**Reference: Response to First Review Comments  
Zoning By-law Amendment Application  
105, 4051, 4050 Sencha Terrace and 2 unaddressed parcels  
City File: D02-02-21-0110  
Novatech File: 121116**

Please find below in bold our responses to first review comments (including UDRP comments) on the above application. The responses are to be read along with the following documents, sent via a separate link:

Figure 1: Proposal superimposed on Barrhaven Downtown Secondary Plan Schedule A - Land Use

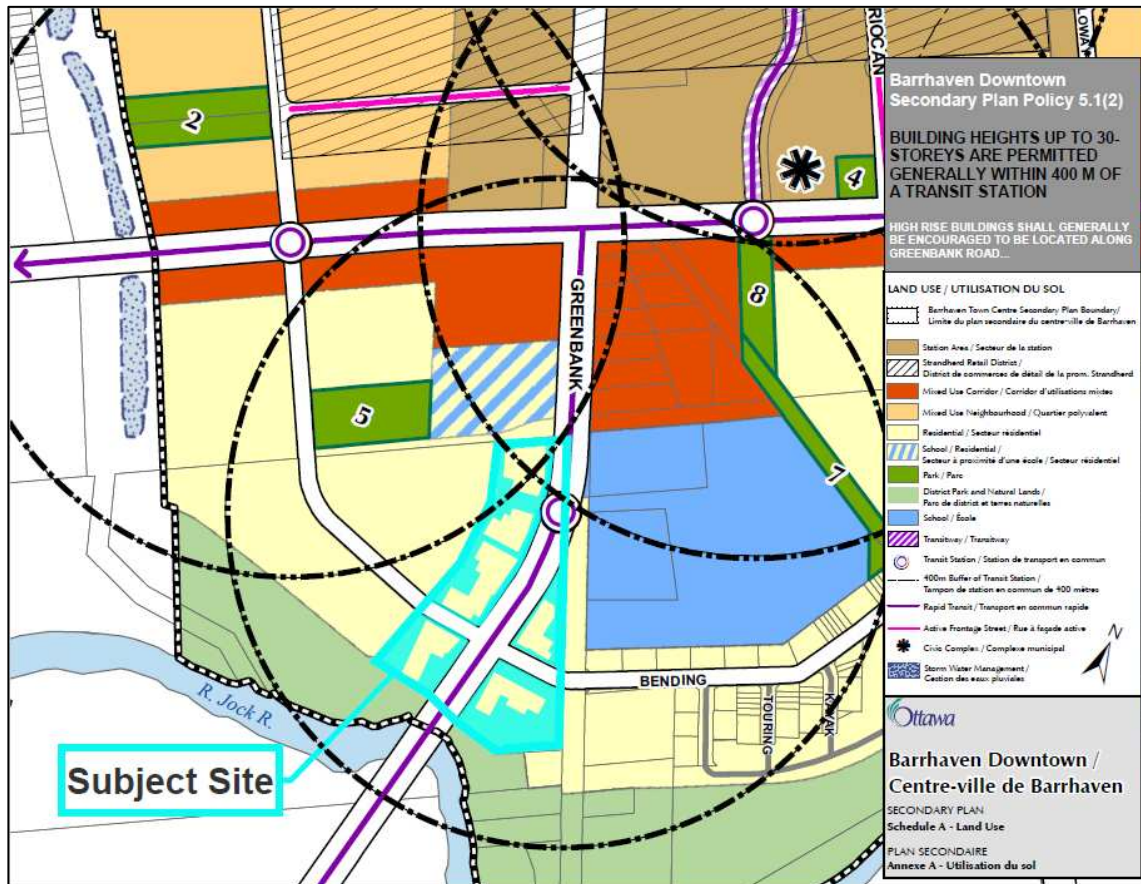
3. The Design Brief and Planning Rationale lacks critical information to allow for an appropriate evaluation of the proposed built form design and the implementing rezoning application. Please include the following information in the resubmission:
  - More detailed planned context of the broader surrounding area and the built form vision for Barrhaven Downtown. This can be illustrated on a more detailed map and 3-d models that show all proposed and potential developments.

**Response: Refer to the 3D massing in the revised architectural plans by Neuf. Figure 1 below superimposes the proposal on Schedule A – Land Use of the Secondary Plan, showing its location relative to where 30 storey buildings are intended to locate (within the black circles). The Subject Site abuts lands to the north that are intended to have the highest concentration of density and mix of uses, reflecting its proximity to a number of transit stations. The Mixed Use Corridor designation to the north will be developed as a**

mid and high rise Town Centre and the development on the Subject Site will complement it.
